SERVICE BULLETIN

M-1176

ADVANCED AUDIO SYSTEM SOFTWARE UPDATE

Figure 1. Identify Software Version Number

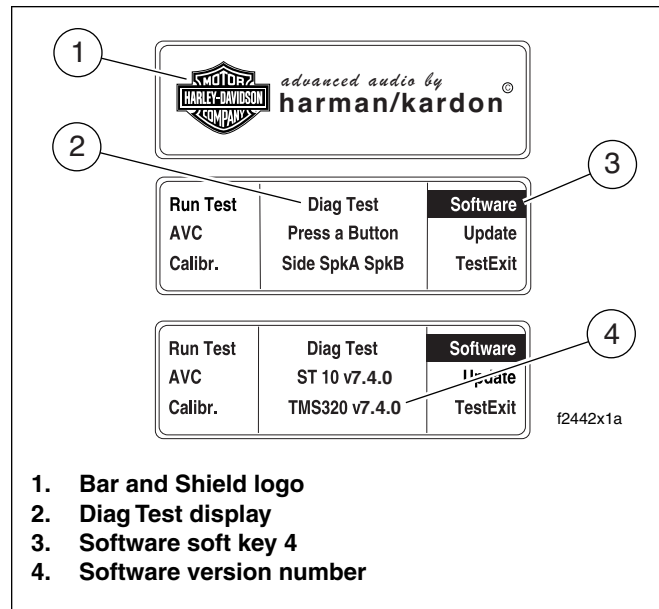
1. Turn the ignition/headlamp key switch to OFF.
2. Simultaneously press and hold any two soft keys (1, 2, 3, 4, 5, or 6).
3. Turn the ignition/headlamp key switch to ACCESS.
4. See Figure 1. Continue to hold the two soft keys while the Harley-Davidson Bar and Shield logo (1) is displayed. The display will cycle to Diag Test (2).
5. Press the Software (3) or number 4 soft key to display the software version number (4).
 - a. If the software version number is lower than 7.8.0, **Update Receiver Software** with the v7.8.0 update CD.
 - b. Receivers with v7.8.0 or higher will not need to be updated.

Figure 2. Update Receiver Software

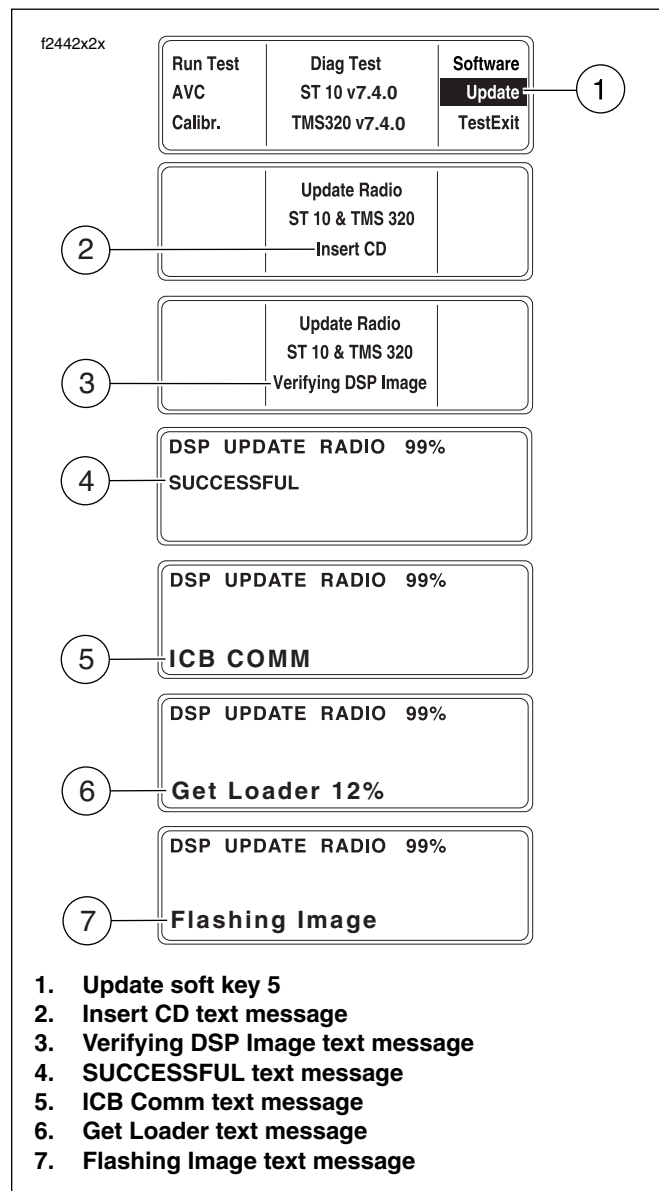
1. See Figure 2. In the Diag Test display, press the Update (1) or number 5 soft key to open the Update Radio display.
2. To update the radio, follow the text prompt, Insert CD (2), and insert the v7.8.0 update CD.

- The text message, *Verifying DSP Image* (3), is displayed as the percentage of download is updated.
 - An automatic power down and up, will proceed the text message, *SUCCESSFUL* (4).
 - Sequentially, *ICB COMM* (5), *Get Loader* (6), and *Flashing Image* (7), text messages will be displayed as the percentage of download is updated.
 - The receiver will again automatically power down and up.
3. After the final automatic power down and up, **Confirm Update Version Number**.

Figure 3. Confirm Update Version Number

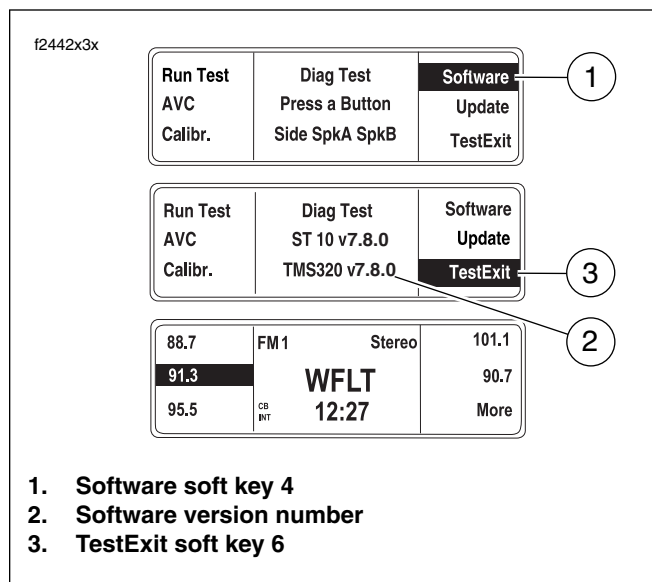
1. Turn the ignition/headlamp key switch to OFF.
2. Simultaneously press and hold any two soft keys (**1**, **2**, **3**, **4**, **5**, or **6**).
3. Turn the ignition/headlamp key switch to ACCESS.
4. Continue to hold the two soft keys while the Harley-Davidson Bar and Shield logo is displayed. The display will cycle to Diag Test.
5. See Figure 3. Press the Software (1) or number **4** soft key to display the software version number (2).
6. Compare the displayed software version number to that on the update CD. If the version number is different from v7.8.0, start over with **Update Receiver Software**.
7. If both version numbers in the display are v7.8.0, press the TestExit (3) or number **6** soft key. The display will open to the current receiver mode.
